Subject: **Vermont Yankee Nuclear Power Station
Technical Specification Proposed Change No. 263 – Supplement No. 33
Extended Power Uprate – Response to Request for Additional Information**

Proposed Technical Specification Change No. 263 – Supplement No. 33

Response to Request for Additional Information

Figure EMEB-B-18-1-1

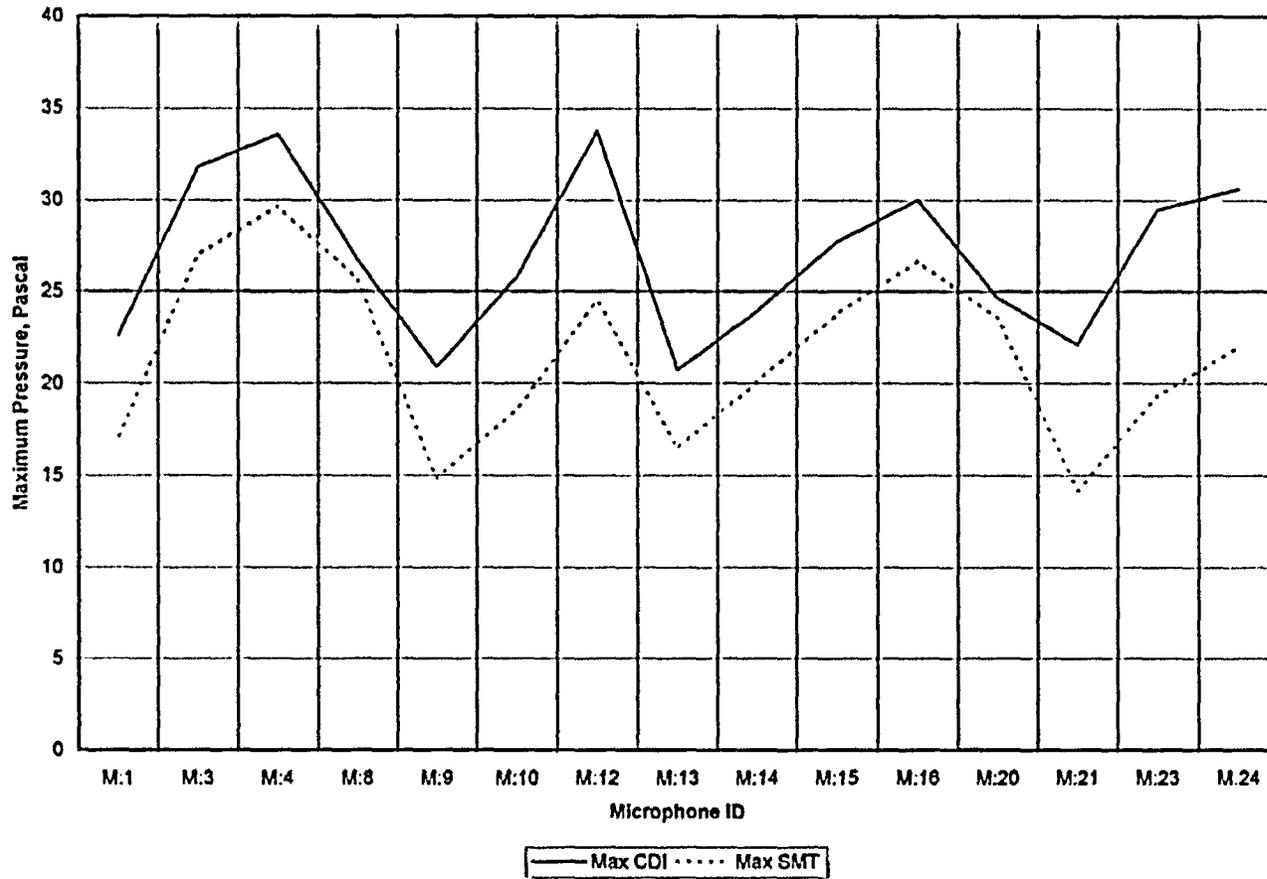
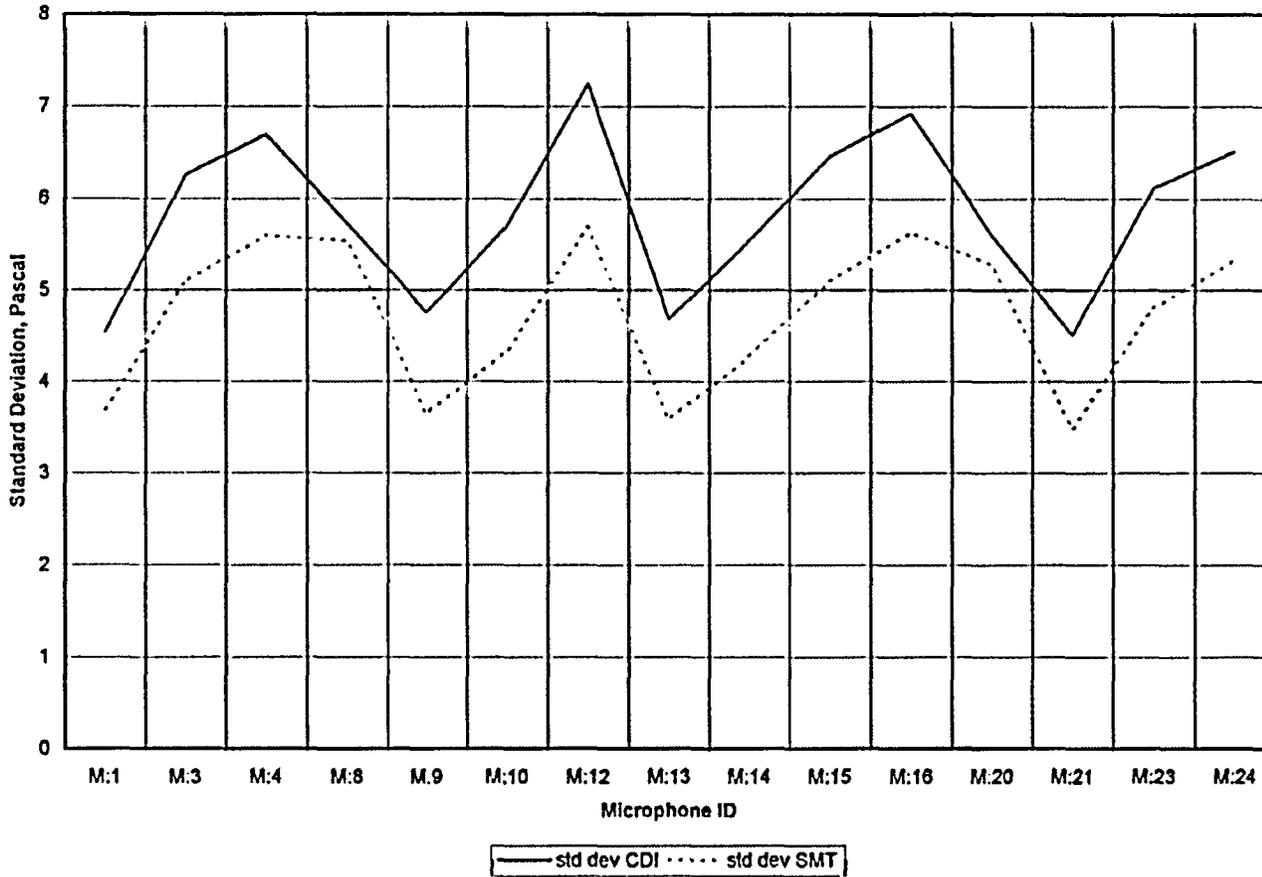
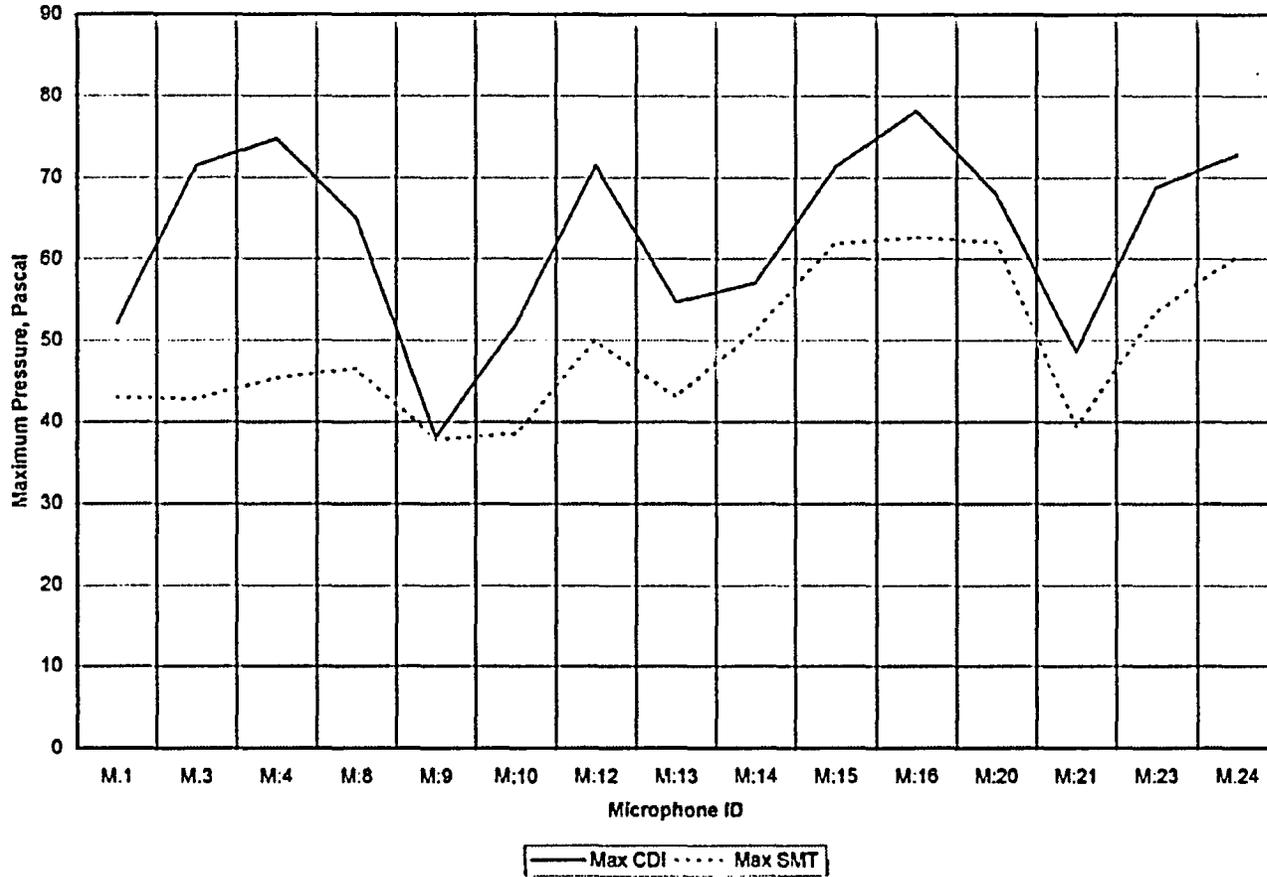
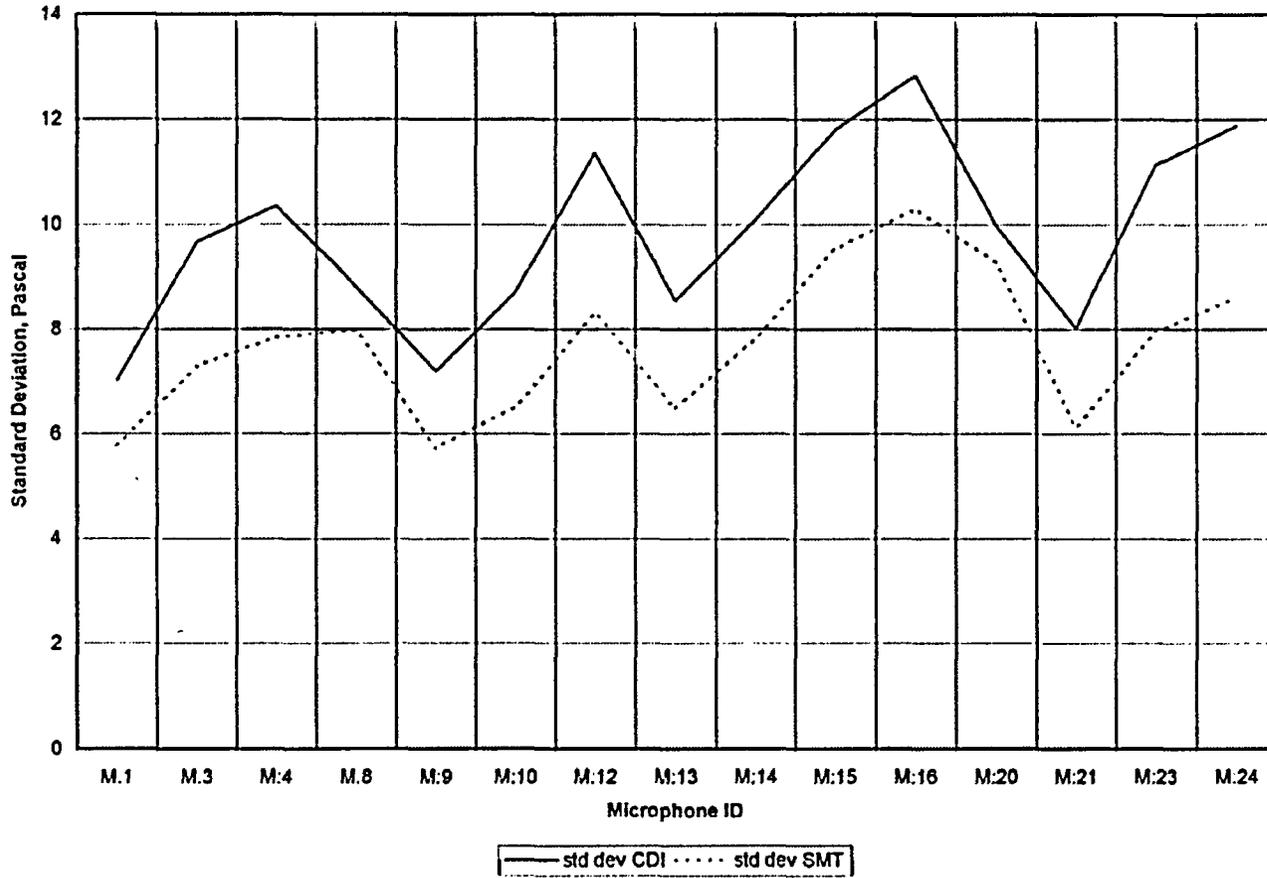
On Page 6 of Attachment 1 to Supplement 26, Entergy states that input for the acoustic circuit model is obtained from pressure transducers installed on instrument lines from the four main steamline (MSL) venturi instrument racks and from strain gauges on each of the four MSLs between the reactor pressure vessel (RPV) nozzles and main steam safety relief valves (SRVs). Provide the basis for the assumption that the venturi pressure transducer measurements are capable of detecting very small pressure fluctuations in the MSL flow that will provide accurate and synchronized input for the acoustic circuit methodology in determining the steam dryer loads. Discuss the validation of the accuracy and synchronization of the venturi pressure transducer measurements in comparison to the MSL strain gauge data.

To assess this rigorously, the SMT data for VY6RUN2 and VY12R1 were reprocessed applying a 240 Hz High Pass filter. The revised, filtered plots Max and RMS signal plots are included as Figures EMEB-B-18-1-1, EMEB-B-18-1-2, EMEB-B-18-1-3, and EMEB-B-18-1-4. As noted with the low frequency turbulence signal removed, the RMS and maximum ACM predictions bound the measured data. This work has been independently reviewed by signal consultant LMS, Inc.
